Sub-Vendor: 	Vendor:  Zarif Sanat Pishro Engineering Co.	PROJECT		Contractor:	Owner/Purchaser: 
		TECHNICAL OFFER COVER FOR CABLE TRAY			
		VENDOR Doc. No.: 1404-204	Rev.: 00		
		CONTRACTOR Doc. No.: ***

TECHNICAL OFFER FOR CABLE TRAY & LADDER

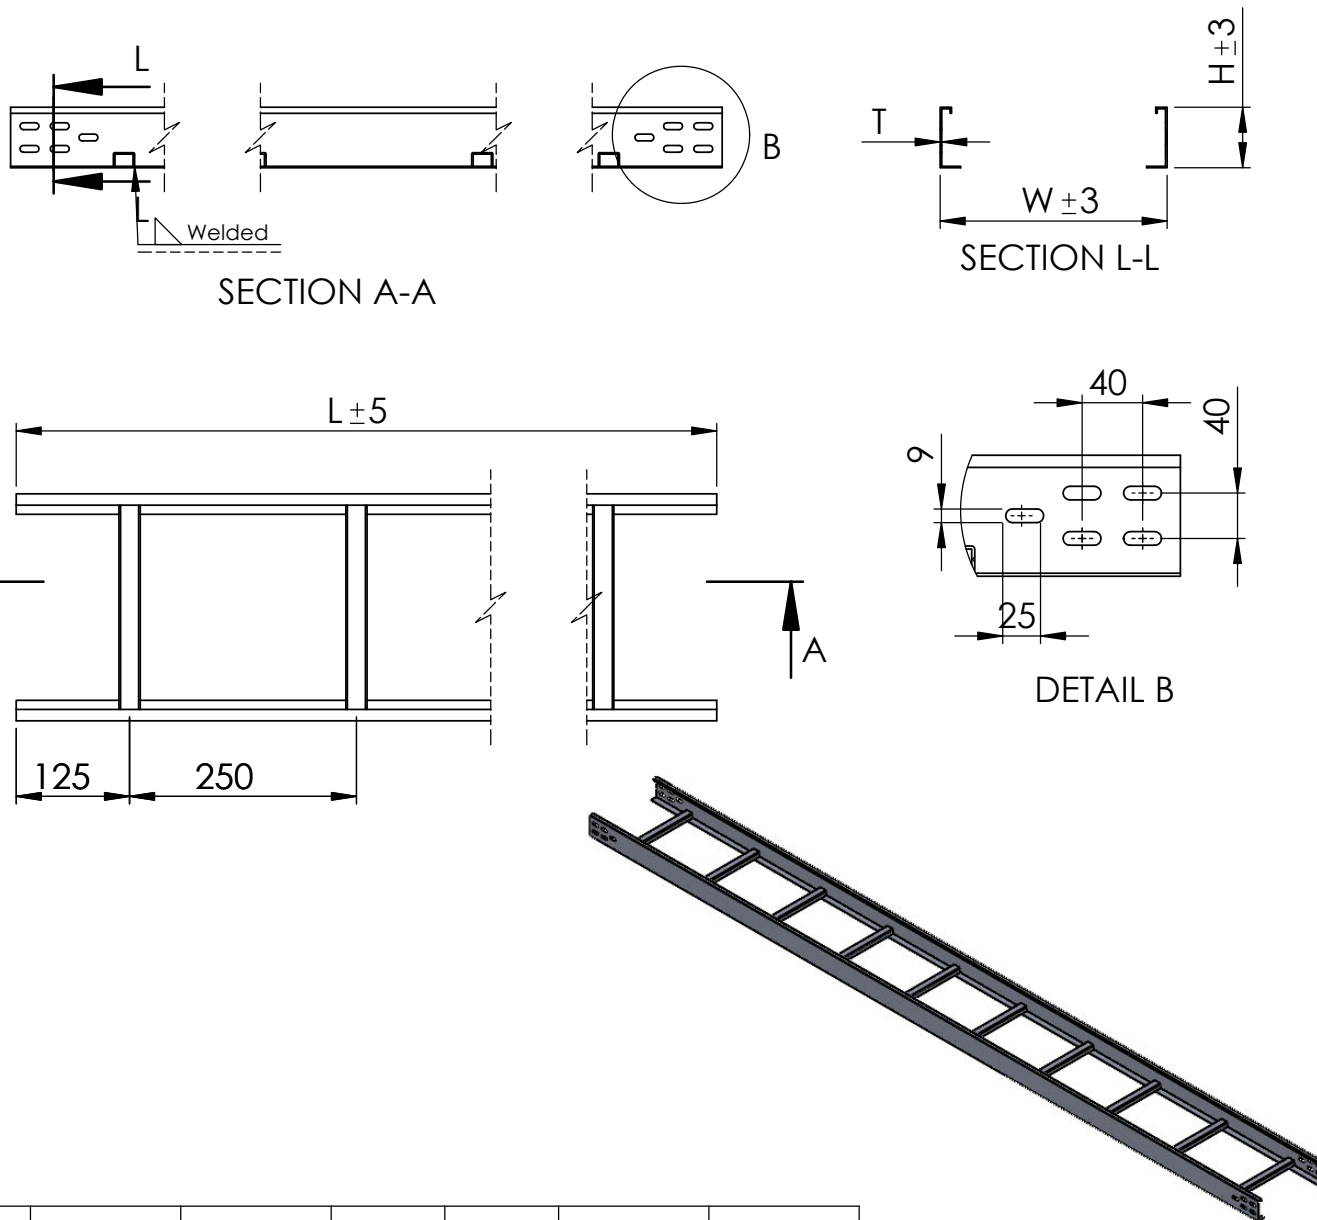
minimum coating shall be mentioned.
